ADDENDUM 1

CSP 23-27

GYMNASIUM ADDITIONS/IMPROVEMENTS FOR CAVAZOS & TREVINO ELEMENTARY SCHOOLS

ADDENDUM NO: ONE (1)

EXISTING
CONDITIONS &
DEMO

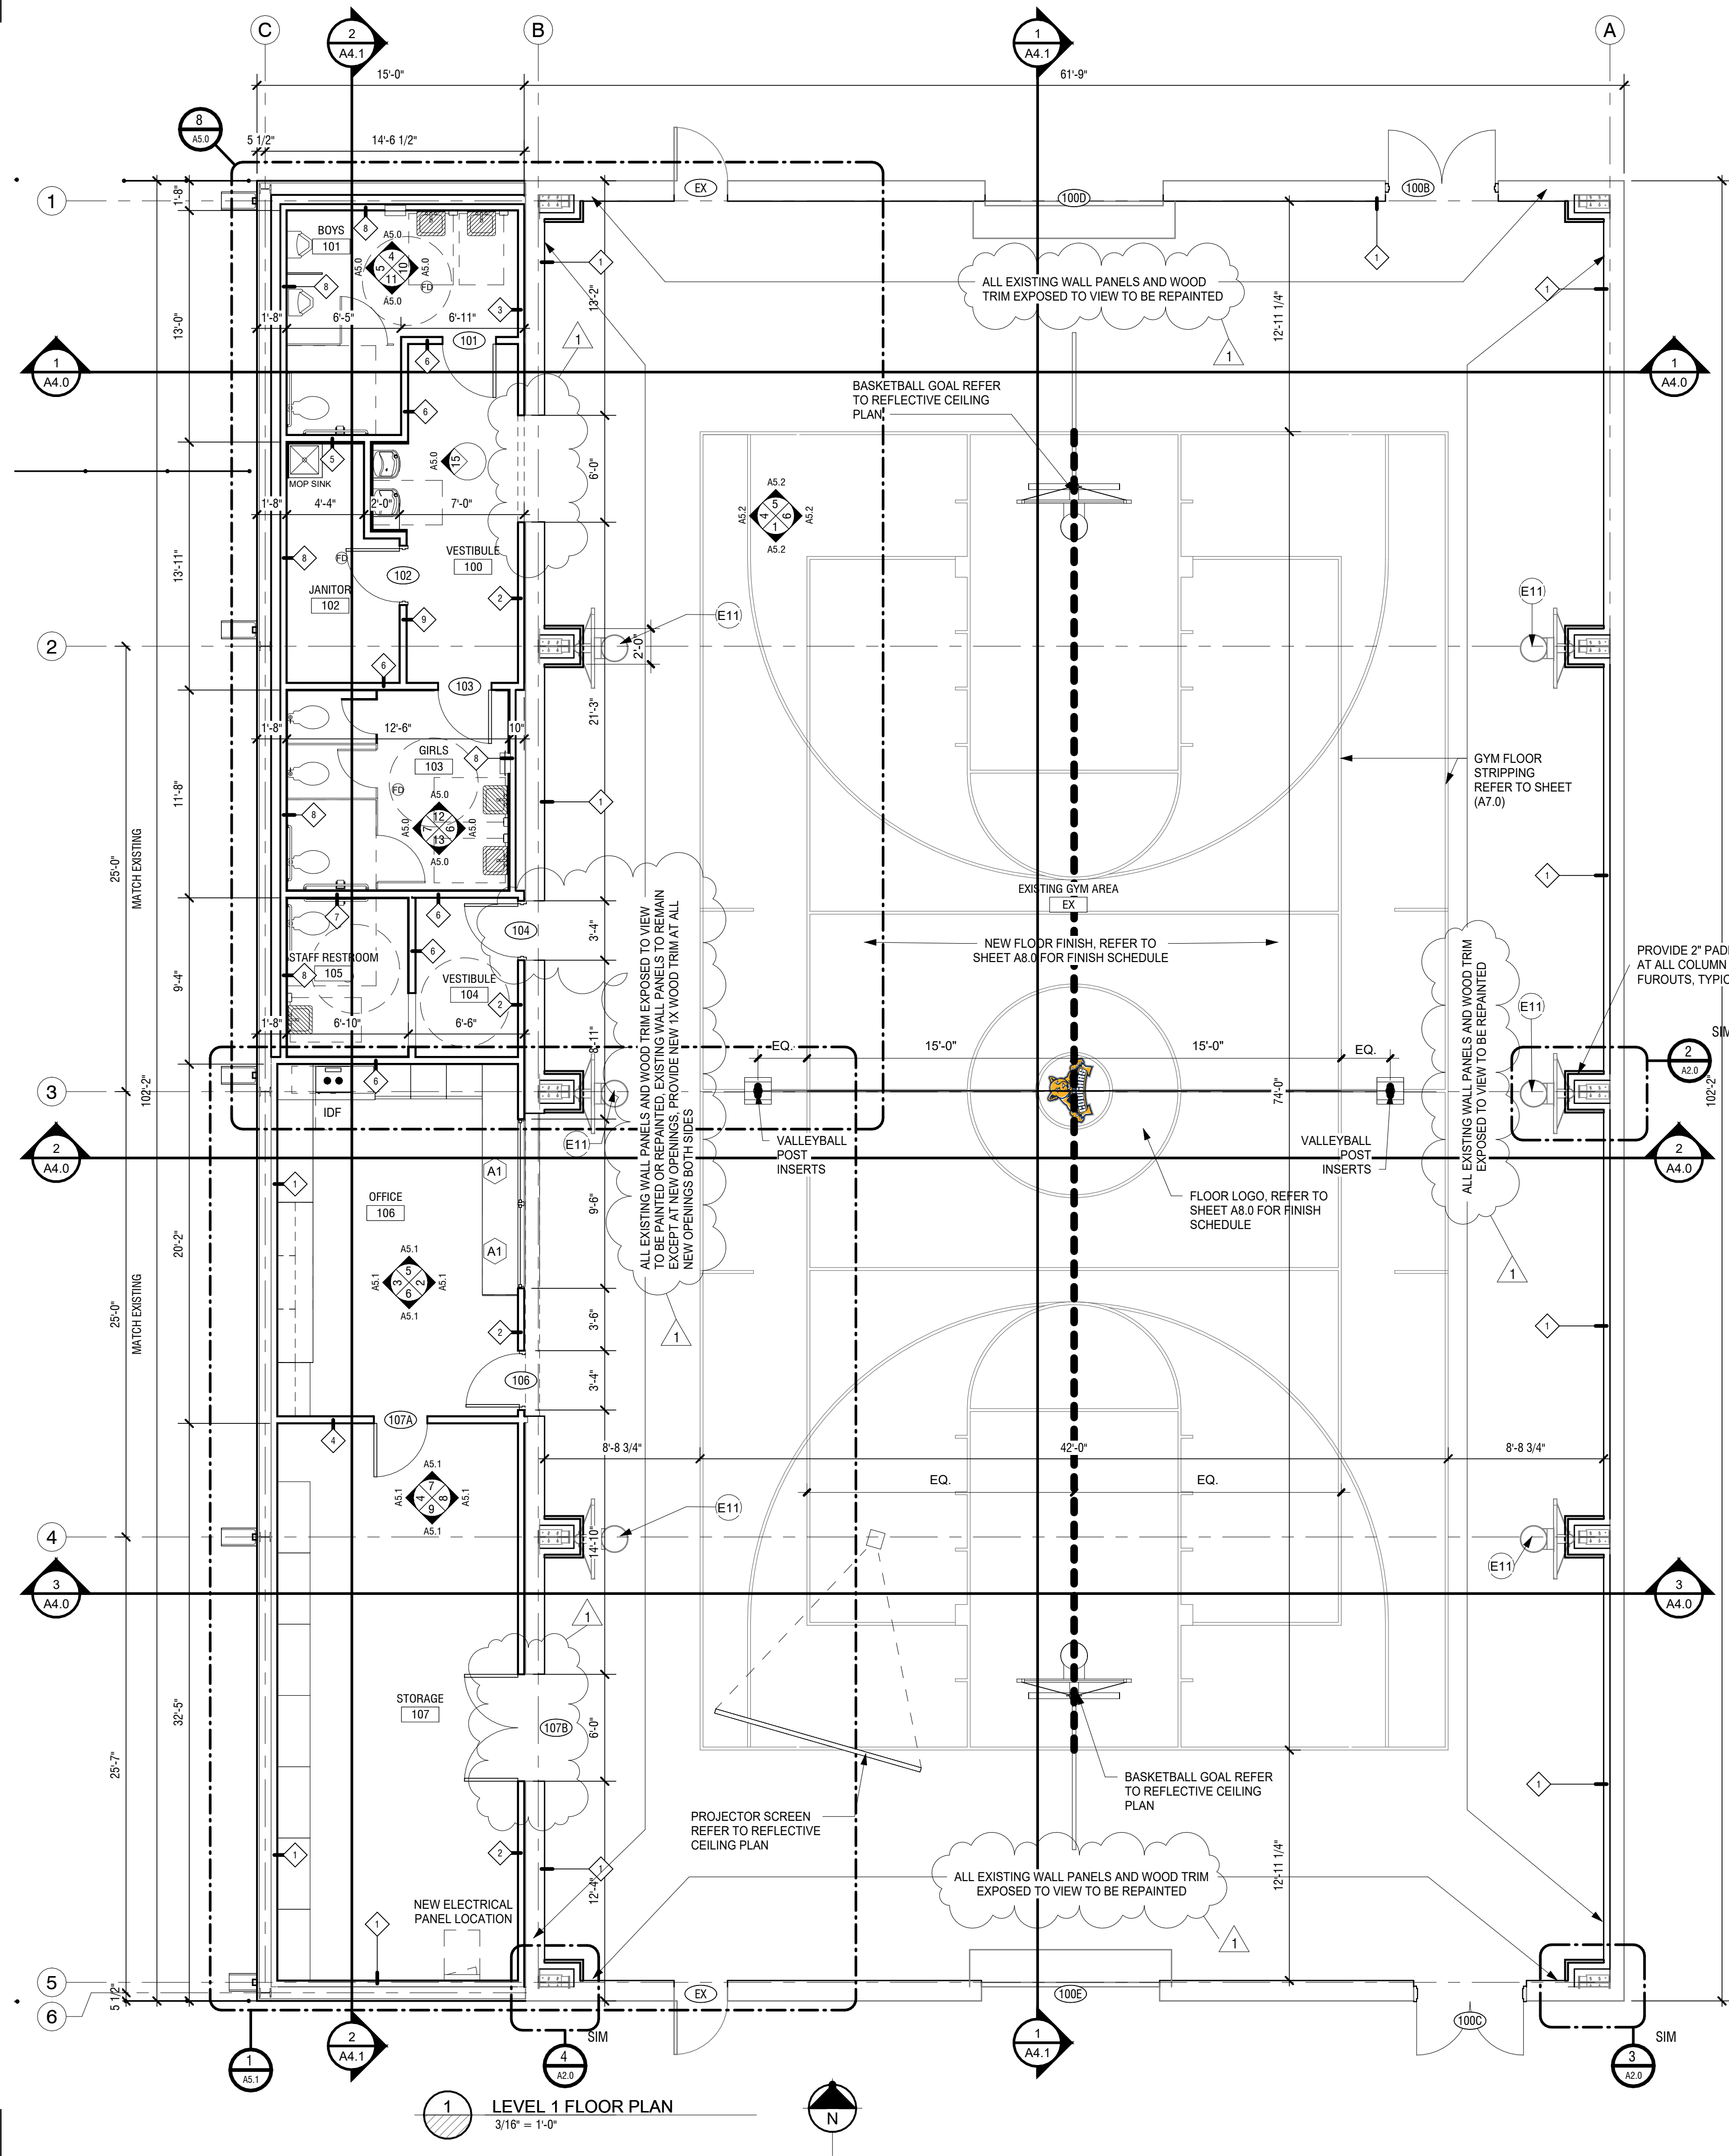
1. SHEET A0.1 EXISTING CONDITIONS & DEMO (INCLUDED HEREWITH)
 - a. At EXISTING KEYNOTES, add keynote "(E12) EXISTING INTERIOR WALL FRAMING, WALL PANEL, WALL TRIM, AND EXISTING WALL INSULATION TO REMAIN"

- b. At EXISTING KEYNOTES, add keynote "(E13) EXISTING CEILING INSULATION AND SUPPORT SYSTEM TO REMAIN"
 - c. At detail 6/A1.0 delete note "DEMOLISH AND REMOVE EXISTING INTERIOR WOOD PANELING AS REQUIRED FOR NEW WALL FINISH AND NEW CONDUIT AND ELECTRICAL AS REQ., REFER TO MEP" and replace with, "REMOVE AND SALVAGE INTERIOR WOOD SIDING PANELS WHERE REQUIRED, REINSTALL PER NEW PLAN"

- d. At EXISTING CONDITIONS pictures, add keynotes (D3) and (E12)
 - e. At 3/A0.1 DEMO PLAN, add keynotes (D3) and (E12) to EXISTING GYM AREA north, east, and south walls.

- f. At DEMOLITION KEYNOTES, modify keynotes (D1) and (D16) to read "NOT USED".
2. SHEET A2.0 NEW FLOOR PLAN (INCLUDED HEREWITH)
 - a. Add notes "ALL EXISTING WALL PANELS AND WOOD TRIM TO EXPOSED TO VIEW TO BE REPAINTED", add this note at gym north, east, and south walls.

A4.0

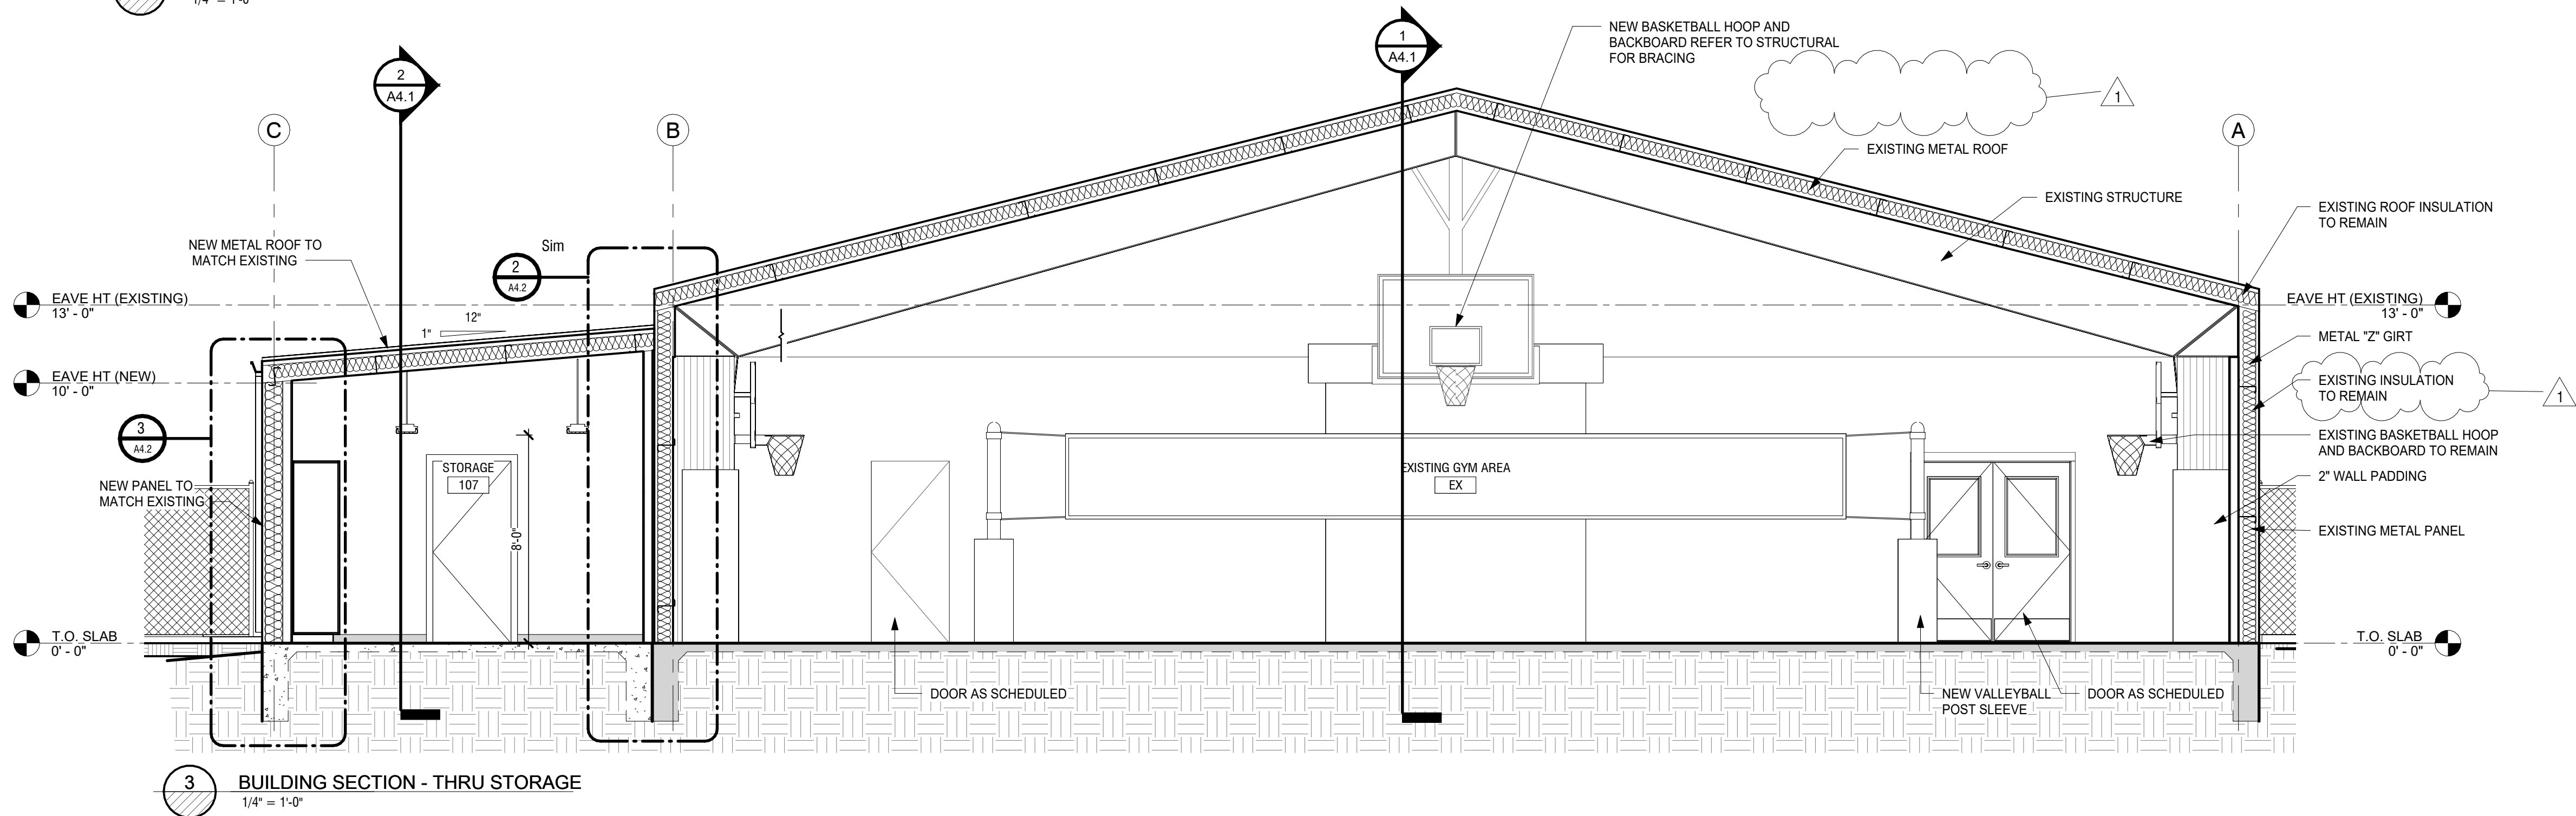
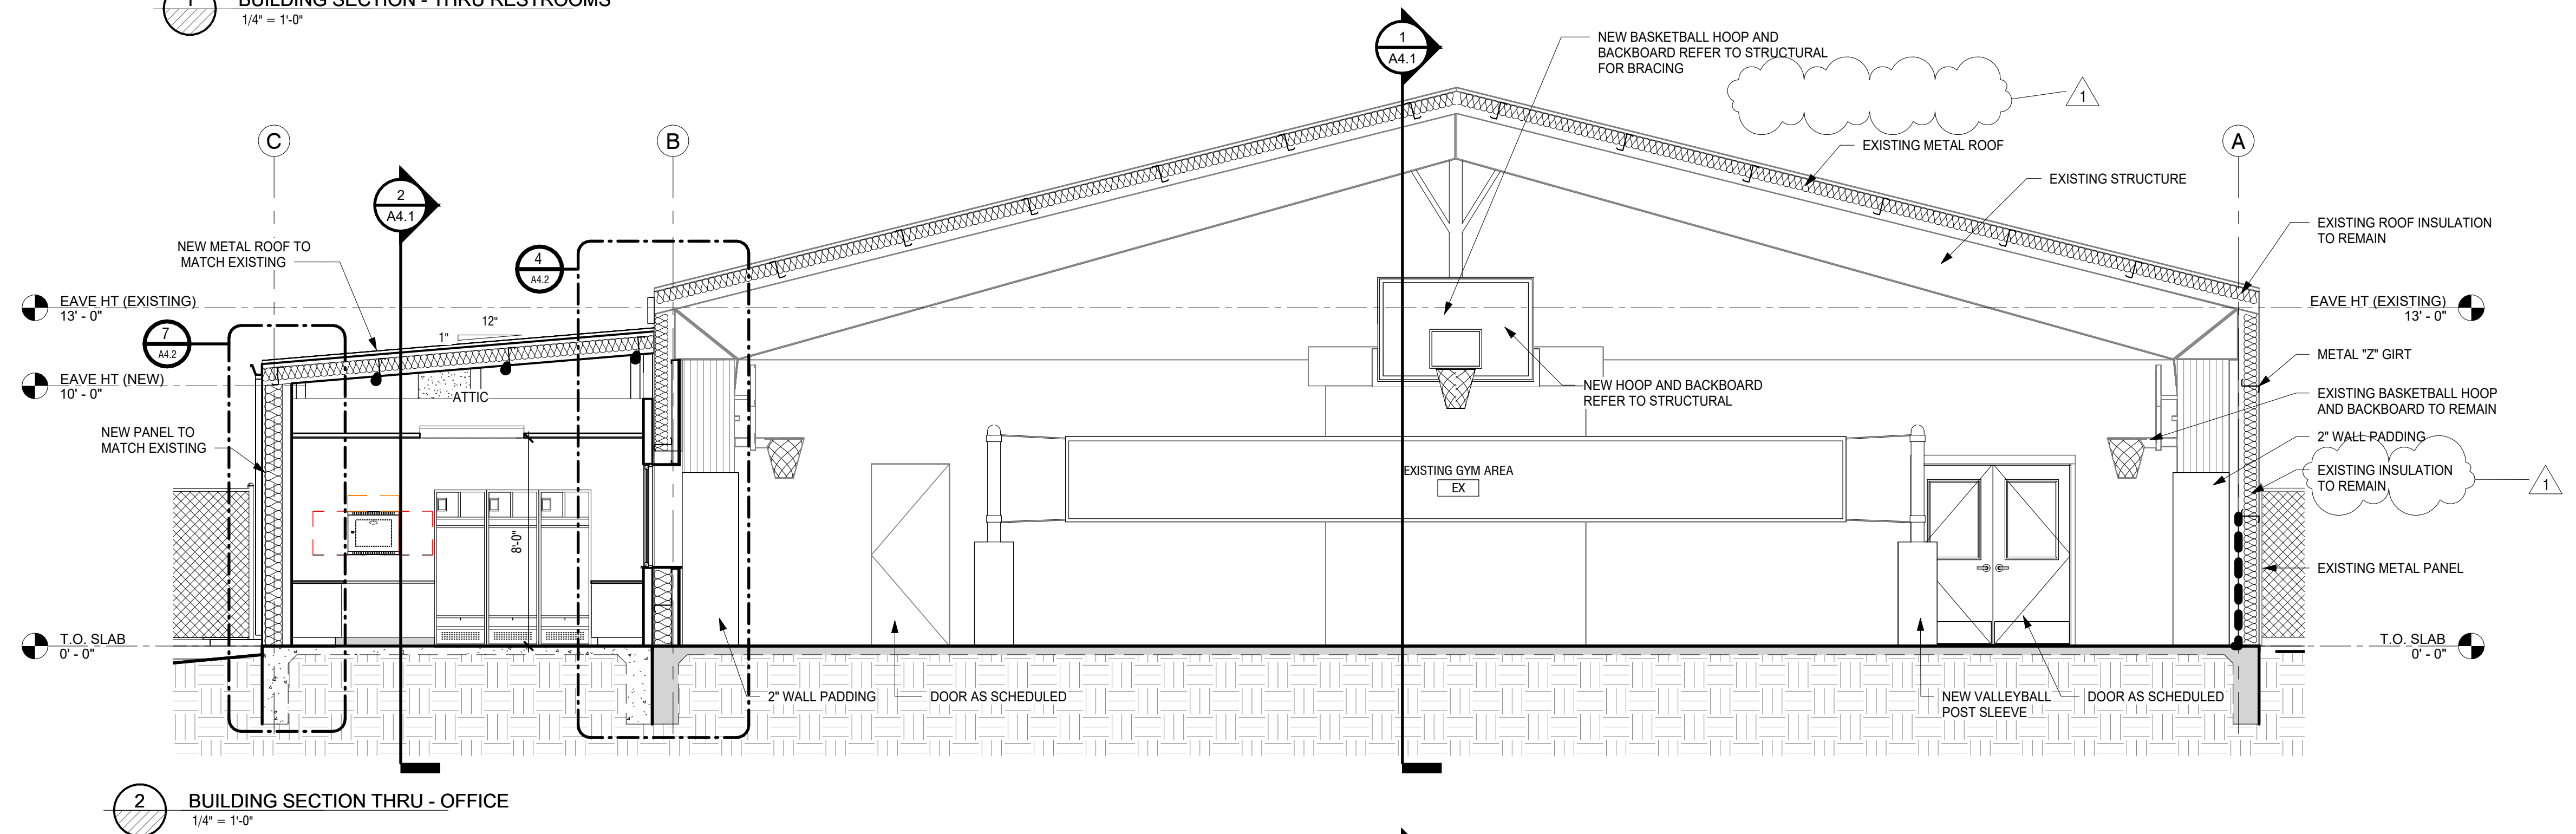
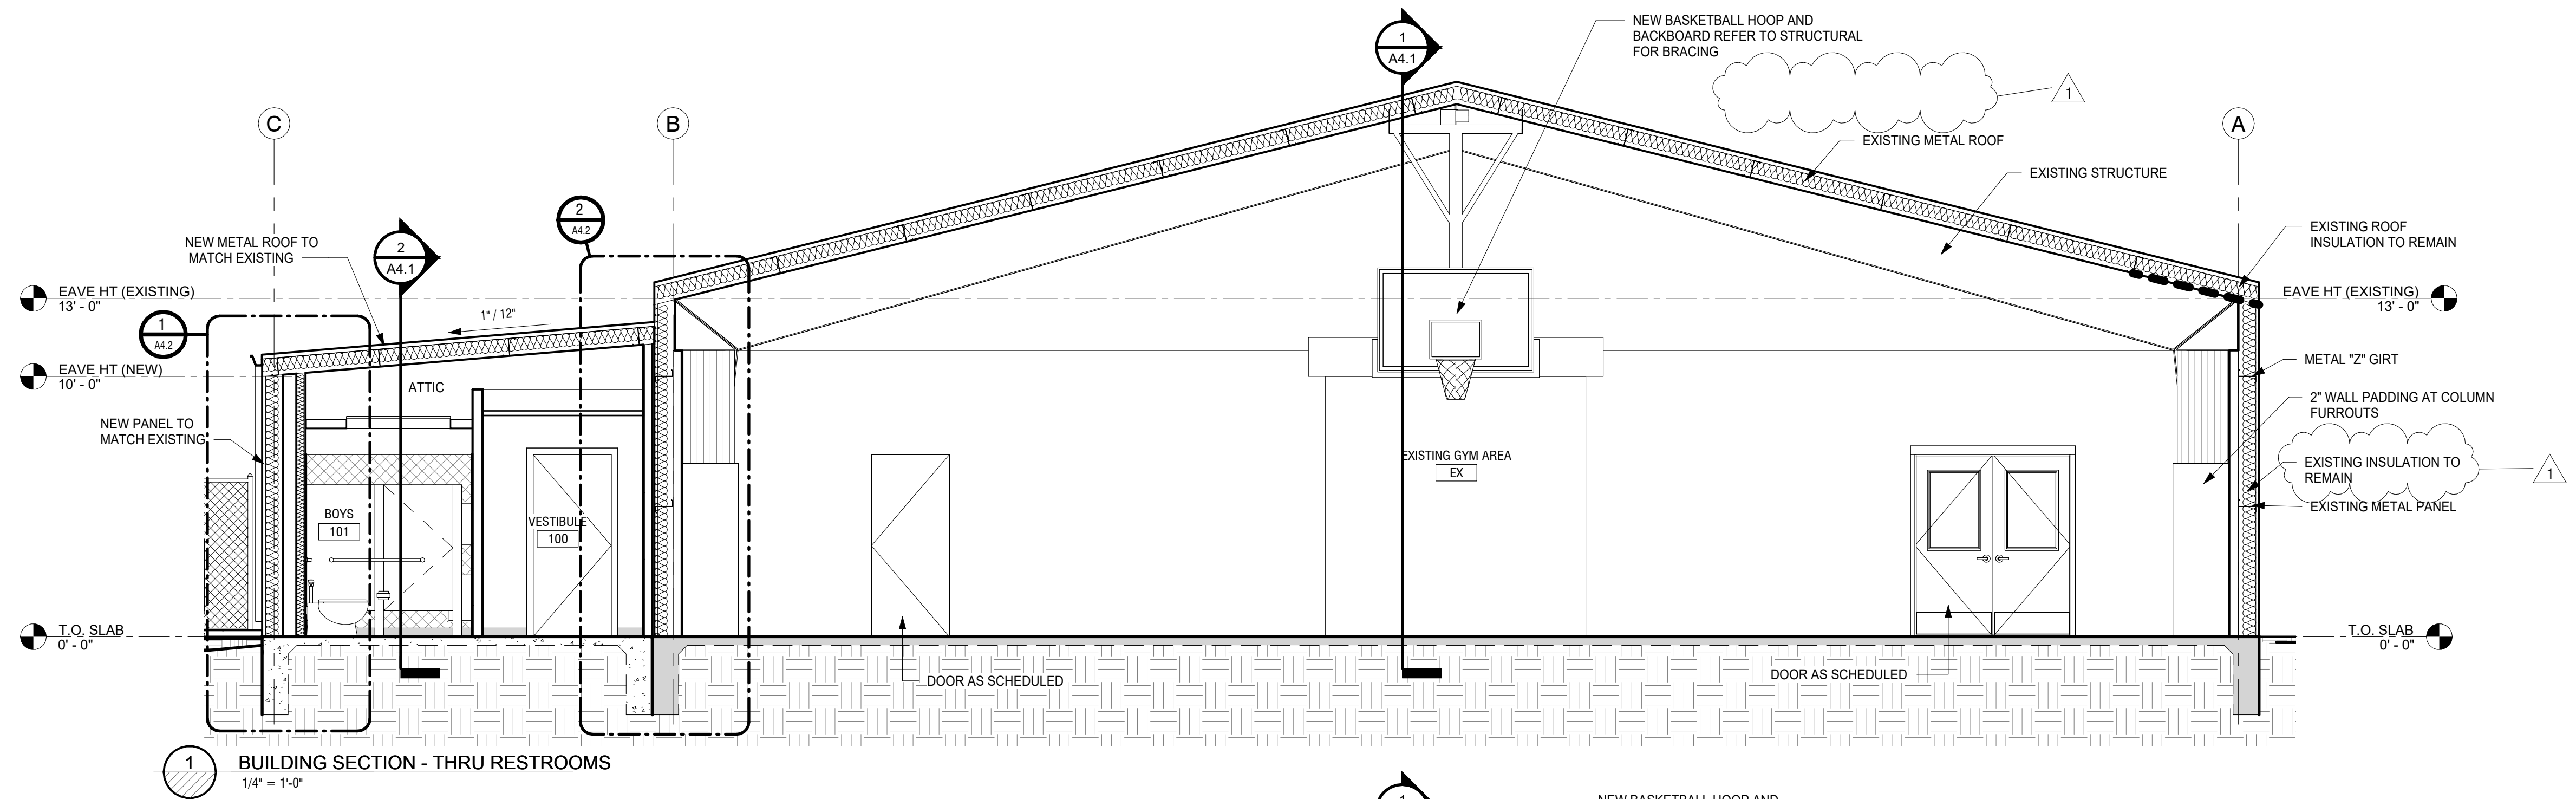
3. SHEET A4.0 BUILDING SECTIONS (INCLUDED HEREWITH)
 - a. At Sections 1/A4.0, 2/A4.0, and 3/A4.0 modify notes as shown for "R-19 BATT INSULATION REFER TO ALTERNATE NO 1" and replace with note "EXISTING INSULATION TO REMAIN"

- b. At Sections 1/A4.0, 2/A4.0, and 3/A4.0 delete notes "EXISTING STRUCTURE TO BE RE-PAINTED" and replace with the note "EXISTING STRUCTURE TO REMAIN"
